From: "Vanderkamp, David W." <dwvande@nppd.com>
To: "mct@nrc.gov" <mct@nrc.gov>
Date: 8/22/02 3:19AM
Subject: FW: Updated version of draft response to RAIs (MSIV leakage path)

ATTACHMENT 1
NPPD RESPONSES TO USNRC
REQUEST FOR ADDITIONAL INFORMATION
REGARDING COOPER NUCLEAR STATION SEISMIC REEVALUATION FOR
LICENSE CONDITION 2.C.(6)

Figure 1. IPEEE RLE Floor Response Spectra for the Control Building

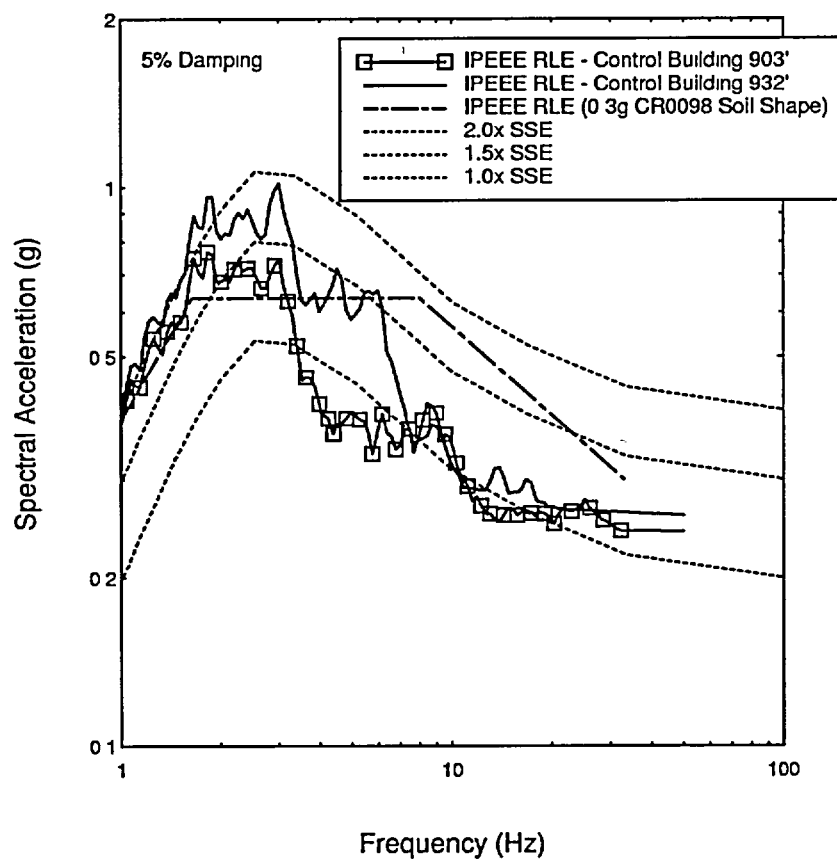
1. In your submittal (Reference 1), you indicated that the 2.0xSSE [safe shutdown earthquake] ground response spectrum (GRS) envelopes the floor response spectra (FRS) at elevation 932'-6" in both the Control Building (CB) and Reactor Building. However, Figure 4.5 shows that the FRS at elevation 932'-6" in the CB is higher than the 2.0xSSE GRS. Explain the discrepancy. Also, provide a figure, which confirms that the 2.0xSSE GRS envelopes the FRS at elevation 903'-6" in the CB.

Response: Figure 4.5 from Reference 1 (EE 01-147, Rev. 0, Attachment 9.2, Page 5) is duplicated below as Figure 1. The FRS for CB 903'-6" has been added to this figure, which shows that 2.0xSSE GRS completely envelopes the FRS for CB 903'-6".

As stated above, 2.0xSSE GRS does not completely envelop the FRS for CB 932'-6". While 2.0xSSE GRS does not completely envelop the CB 932'-6" FRS, 2.0xSSE GRS was judged to be an adequate estimate of the FRS at TB 932' because:

Figure 4. Comparison of Shear (V) / Tension (T) Interaction Curves

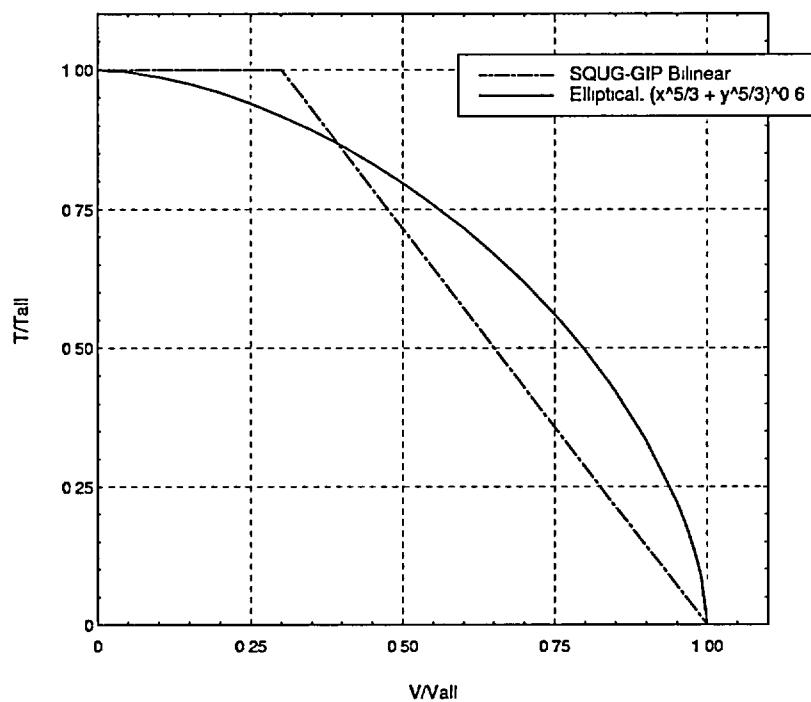
5. You used Equation 5.9 in Reference 1 for determining the adequacy of the anchor bolt capacity. Discuss how Equation 5.9 is more conservative than the bilinear formulation given in the SQUG-GIP (Reference 3).

Response: The two interaction curves are shown below in Figure 4. When the shear ratio (V/V_{all}) is less than about 0.4, the elliptical curve is more conservative. When the shear ratio is greater than about 0.4, the SQUG-GIP curve is more conservative.

SQUG-GIP primarily addresses the evaluation of equipment and equipment anchorage. In conducting the equipment anchorage evaluation for this program, the SQUG-GIP interaction curve was applied. For pipe supports, the test data summarized in Reference 7.26 (EPRI Report TR-101968, Tier 2, Volume 3, "Guidelines and Criteria for Nuclear Piping and Support Evaluation and Design", Volume 3: Anchor Bolt Capacity and Installation Tolerances) of EE 01-147 recommends that the elliptical relationship better represents test results for pipe supports. Thus, while the elliptical curve is not more conservative than the bilinear formulation in all possible combinations of shear/tension interaction, the elliptical curve is considered to be more appropriate for pipe support evaluations.
